Subject: Issuance of Amendment No. 13 to Facility Operating License No. NPF-41  
and Amendment No. 7 to Facility Operating License No. NPF-51 for  
Palo Verde, Units 1 and 2

AMENDMENT TO FACILITY OPERATING LICENSE

Amendment No. 13  
License No. NPF-41

SAFETY EVALUATION BY THE OFFICE OF NUCLEAR REACTOR REGULATION  
RELATED TO AMENDMENT NO. 13 TO FACILITY OPERATING LICENSE NO. NPF-41  
AND AMENDMENT NO. 7 TO FACILITY OPERATING LICENSE NO. NPF-51  
ARIZONA PUBLIC SERVICE COMPANY, ET AL.  
PALO VERDE NUCLEAR GENERATING STATION, UNIT NOS. 1 AND 2  
DOCKET NOS. STN 50-528 AND STN 50-529

FIGURE 6.2-1  
OFFSITE ORGANIZATION

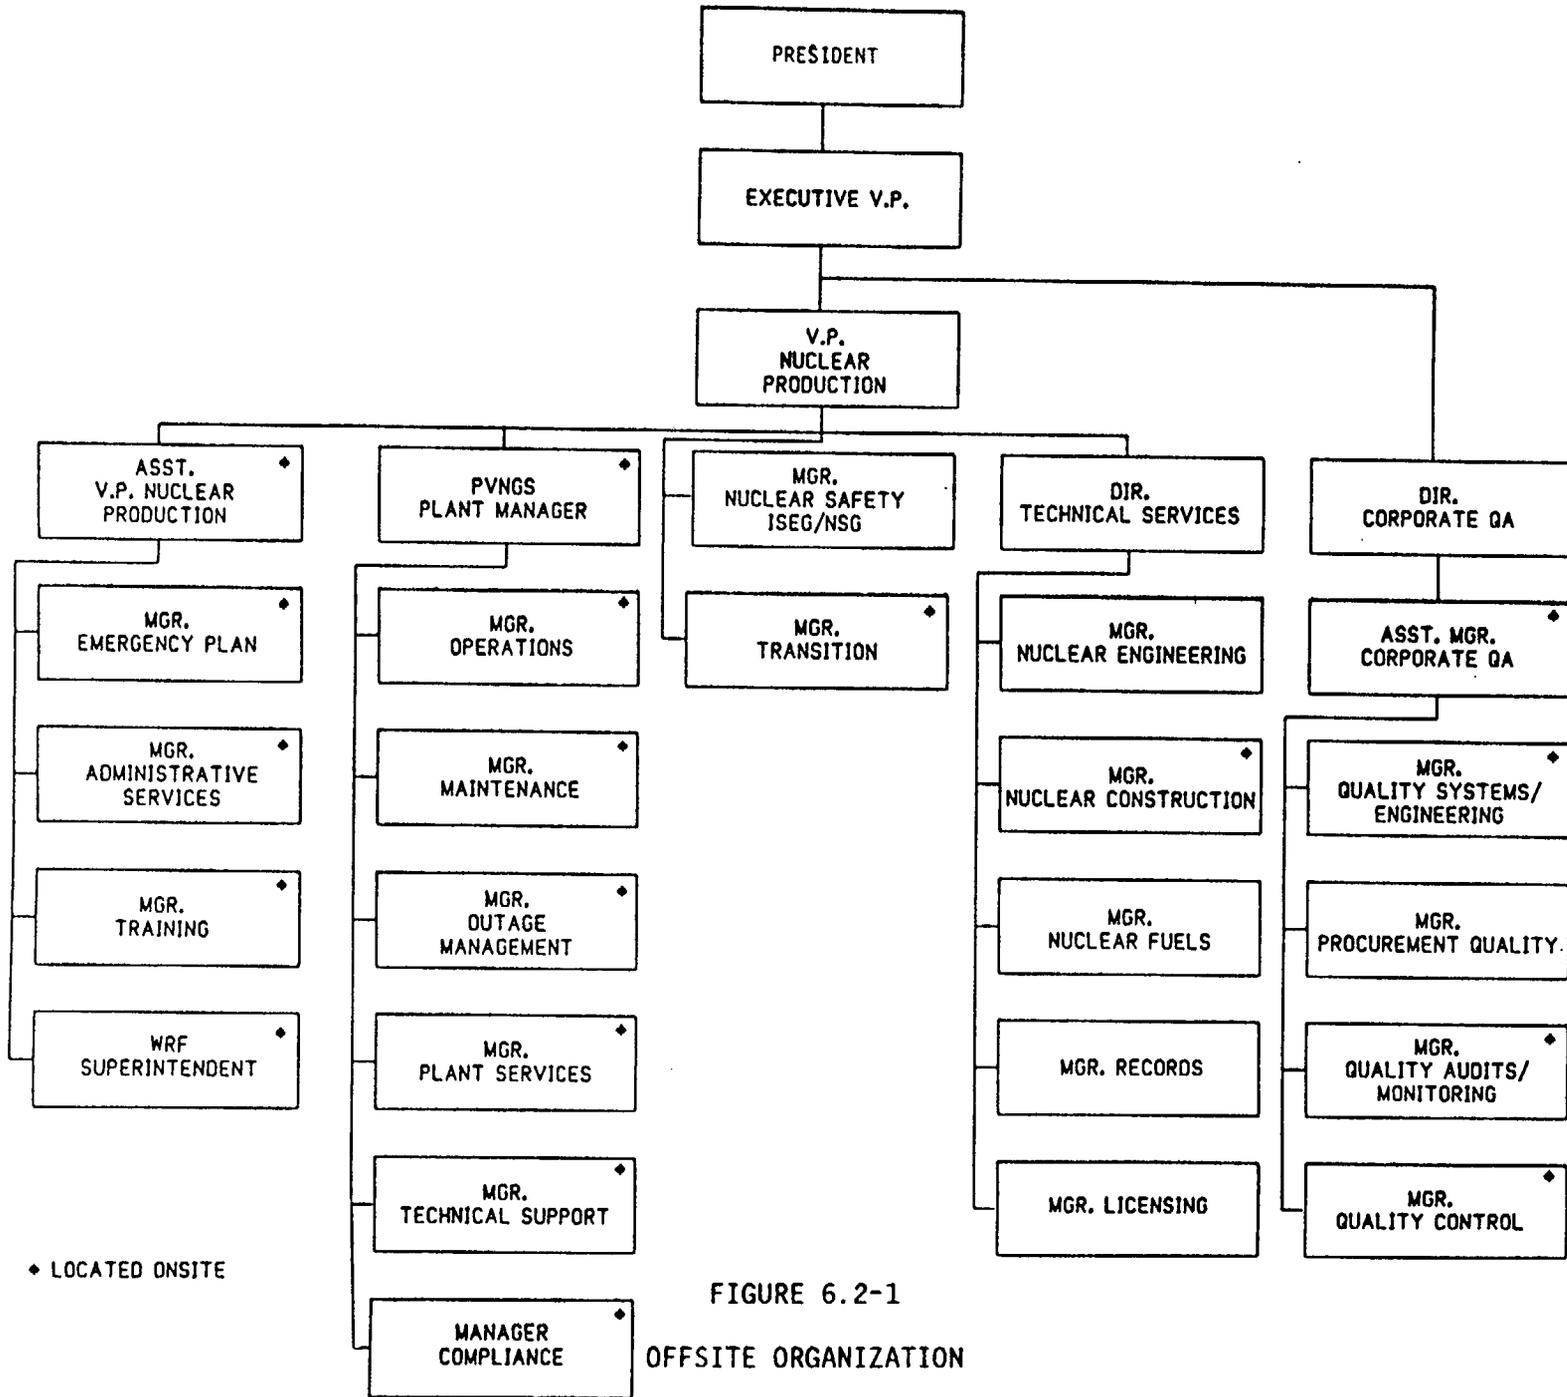
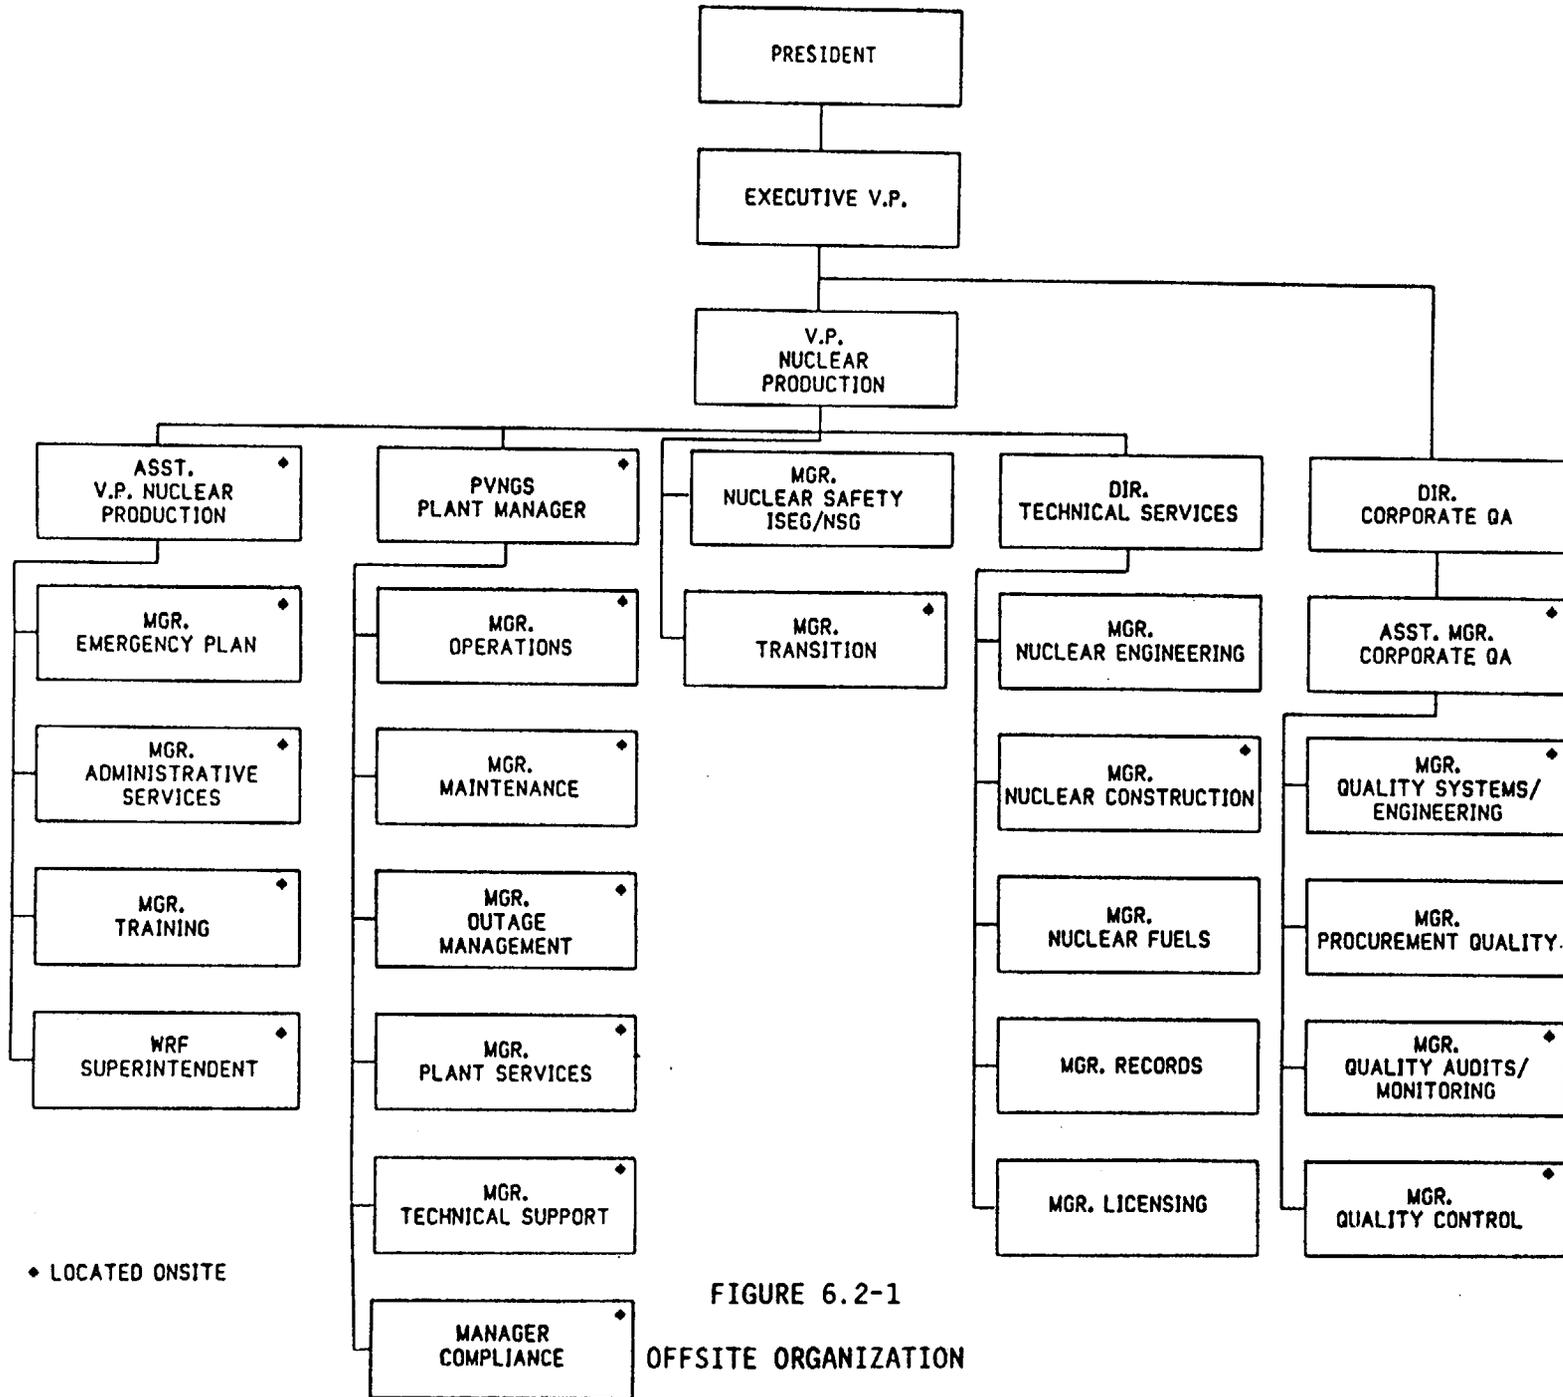
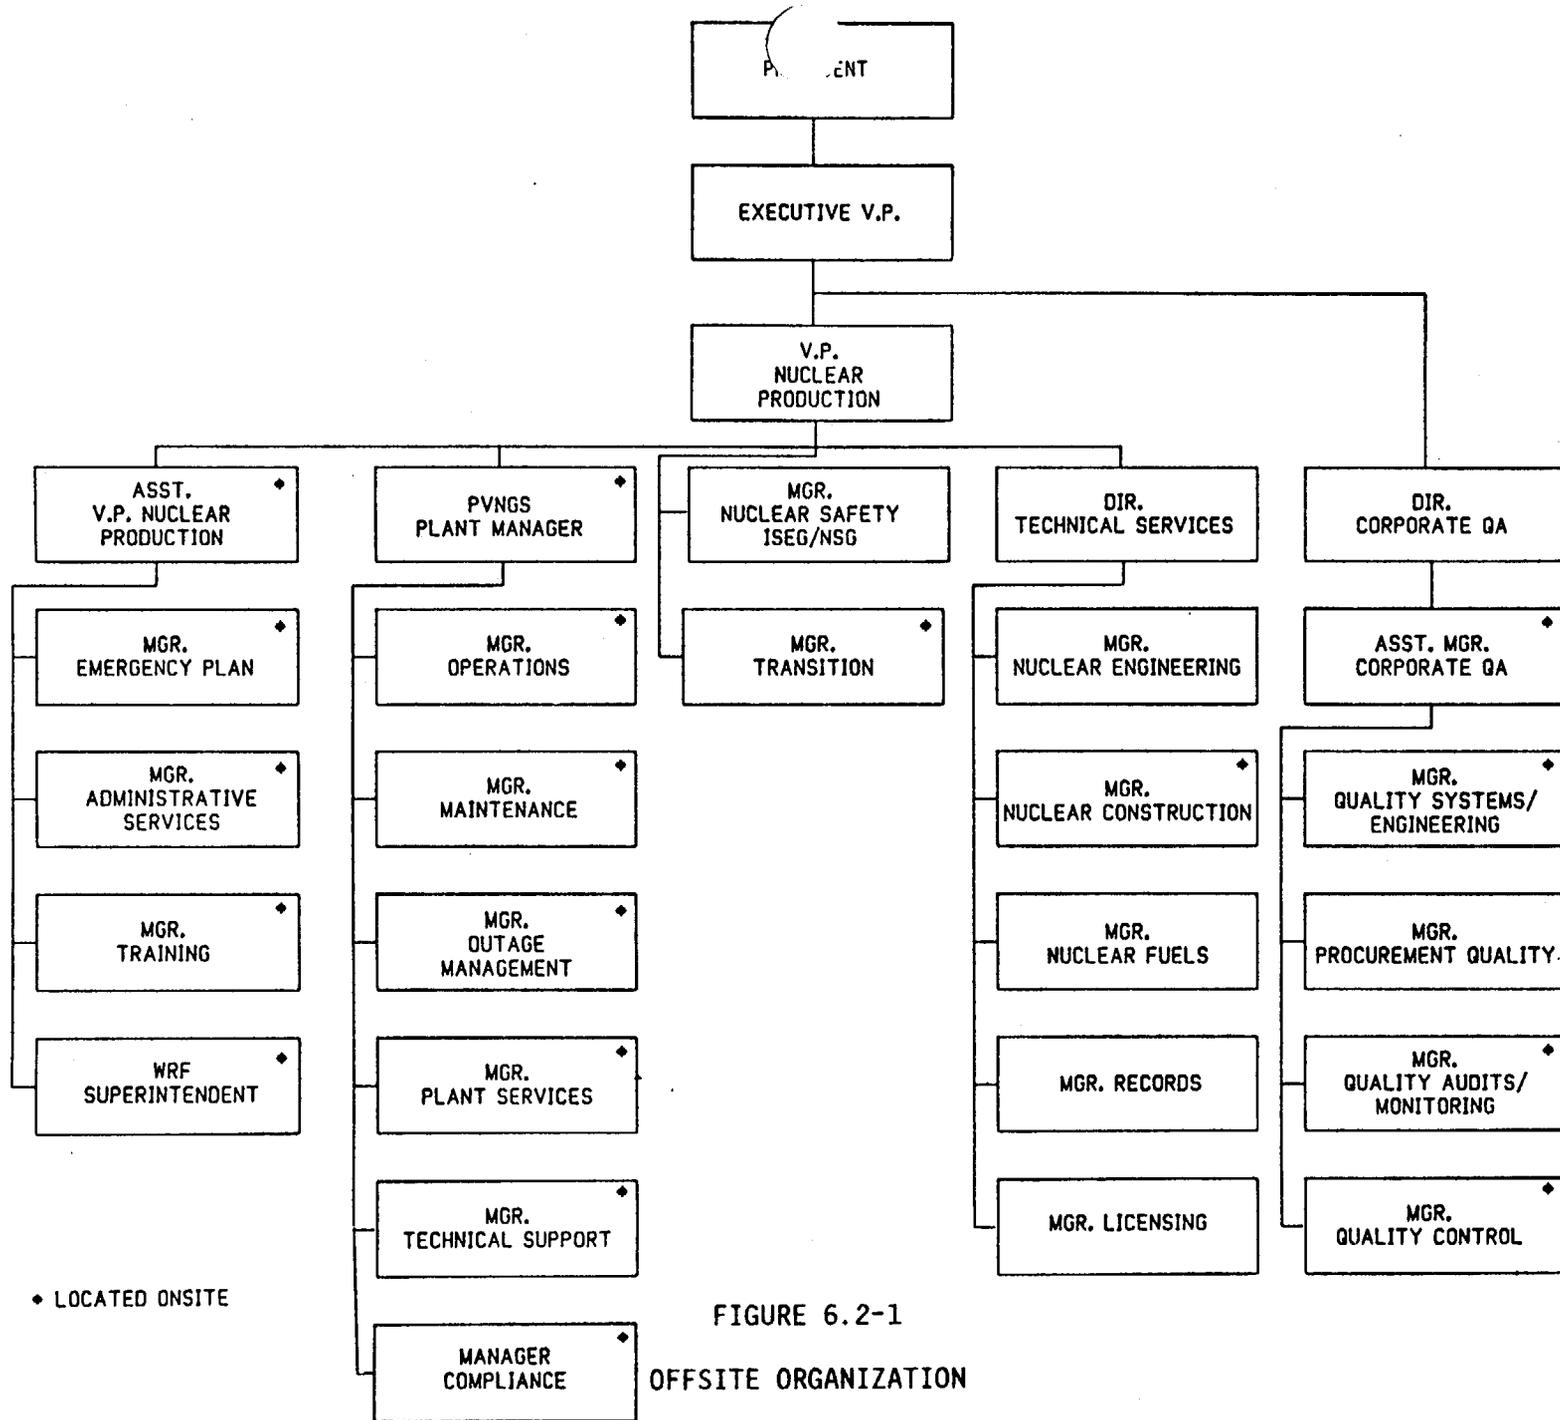
Figures 6.2-1 and 6.2-2 of the Technical Specifications for Palo Verde, Units 1 and 2 provide the offsite and onsite organizational structure for the Palo Verde plant. In its application, dated November 6, 1986, APS proposed the following changes to the figures:

- (A) The Executive Vice President, who is now shown as reporting to the Chief Executive Officer, would be reporting to the President and Chief Operating Officer.
- (B) The Compliance Department, which is now shown as reporting to the Technical Support Manager, would be reporting to the Plant Manager.
- (C) Change the title of Figure 6.2-2 to read "Onsite Organization", in lieu of "Onsite Unit Organization".

1. With the proposed changes, the offsite and onsite organizations will continue to meet the requirements of Standard Review Plan Sections 13.1.1 and 13.1.2 - 13.1.3 since the functions of the plant operating staff remain the same and the responsibilities of the Vice President for Nuclear Production also have not changed. Therefore, the staff finds the proposed organizational changes to be acceptable.
